WATER WELL ABANDONMENT-SEALING REPORT FORM

SDP-15-070; MacAlpine

PROPOSAL: SDP-15-070; well must be sealed for Health Dept. approval

SITE INSPECTION SHEET

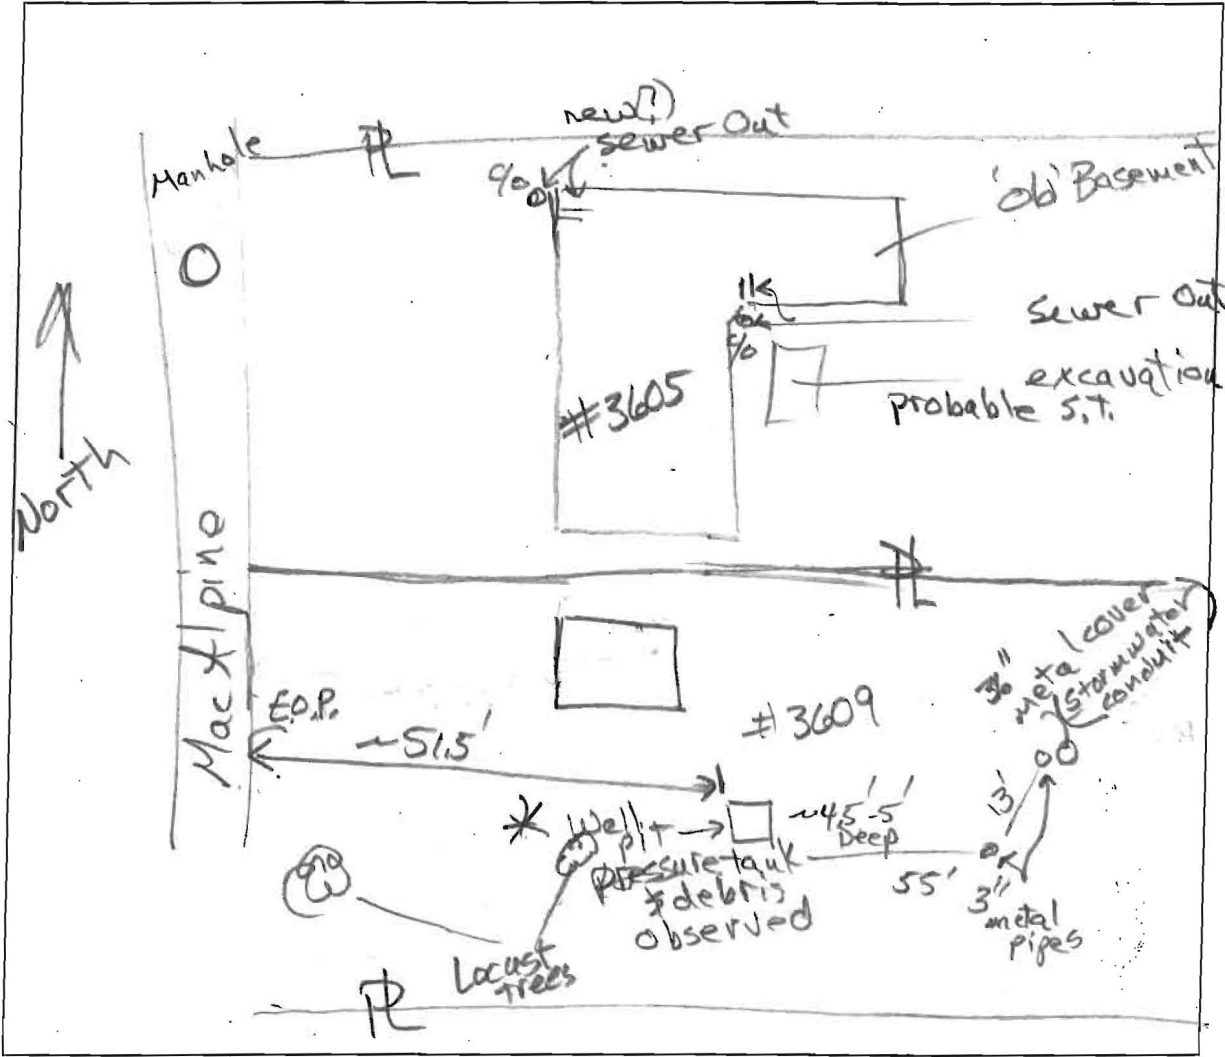
COMMENTS: Pit well; no evidence that it has been sealed; plumbing in pit appears to be intact, though partly covered with debris.

Discharge location of former septic system not found.
